Access Compliance Report

Public Rights-of-Way

(Curb Ramps)

Intersection ID: 7486	Main Street: N_TRYON_ST	Cross Street: OWEN_BV	Location: SE
ADA ID: 3A1C2A0DBFFD	Ramp Type: Perp	Initial Pass/Fail: Fail	Overall Compliance: No
Severity Score: 21.25			
Codes/Mitigation Info/Possible Solution		Field Measurements/Component Compliance

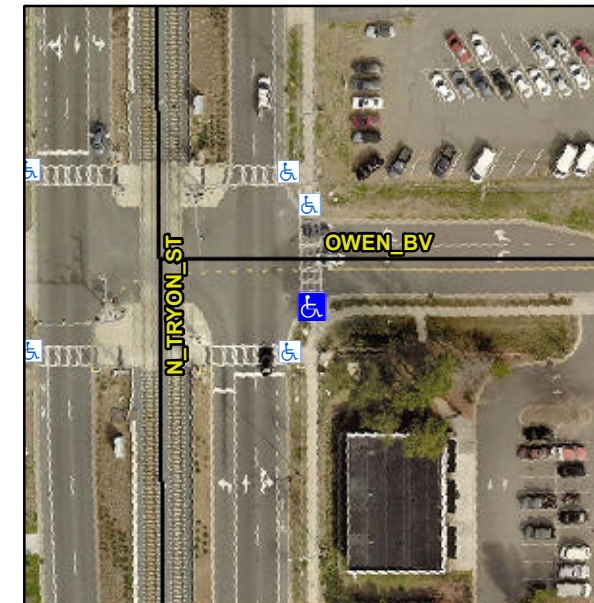
R304.5.1, R304.5.3

Compliance	Description	Data	Compliance	Description	Data
N/A	Ramp Length (in)	91.0	Yes	Ramp Slope (%)	7.3
No	Ramp Width (in)	46.5	No	Ramp XSlope (%)	5.8
N/A	Flare Type LT	N/A	N/A	Flare Type RT	N/A
N/A	Flare Slope LT (%)	N/A	N/A	Flare Slope RT (%)	N/A
N/A	Flare Traversable LT?	N/A	N/A	Flare Traversable RT?	N/A
N/A	Landing Length (in)	N/A	N/A	DWS Provided?	N/A
N/A	Landing Width (in)	N/A	N/A	DWS Contrast?	N/A
N/A	Landing Slope (%)	N/A	N/A	DWS Length (in)	N/A
N/A	Landing X Slope (%)	N/A	N/A	DWS Full Width?	N/A
N/A	Landing Curb? (Y/N)	N/A	N/A	DWS Offset (in)	N/A
N/A	Shared Landing?	N/A			
N/A	Gutter Ponding?	N/A	N/A	Gutter Slope (%)	N/A
N/A	Gutter Lip Ht (in)	N/A	N/A	Gutter X Slope (%)	N/A
N/A	Painted X Walk1?	Yes	N/A	Painted X Walk2?	N/A
	X Walk 1 Direction	To N		X Walk 2 Direction	N/A
N/A	X Walk 1 Width (in)	117.0	N/A	X Walk 2 Width (in)	N/A
	X Walk 1 Slope (%)	1.9		X Walk 2 Slope (%)	N/A
	X Walk 1 X Slope (%)	4.7		X Walk 2 X Slope (%)	N/A

N/A	Ramp inside XWalk1?	Yes	N/A	Ramp inside XWalk2?	N/A
	Road Slope (%)	N/A	N/A	Clear Space?	N/A
	Road X Slope (%)	N/A	N/A	Clear Space to XWalk (in)	N/A
N/A	Any Obstructions?	N/A	N/A	Storm Grate/Utility Hazard?	N/A
	Obstruction Type			Storm Grate/Utility Type	
		N/A			N/A
		Yes		Surface Condition? (G/P)	Good

Remove & Replace Entire Ramp.
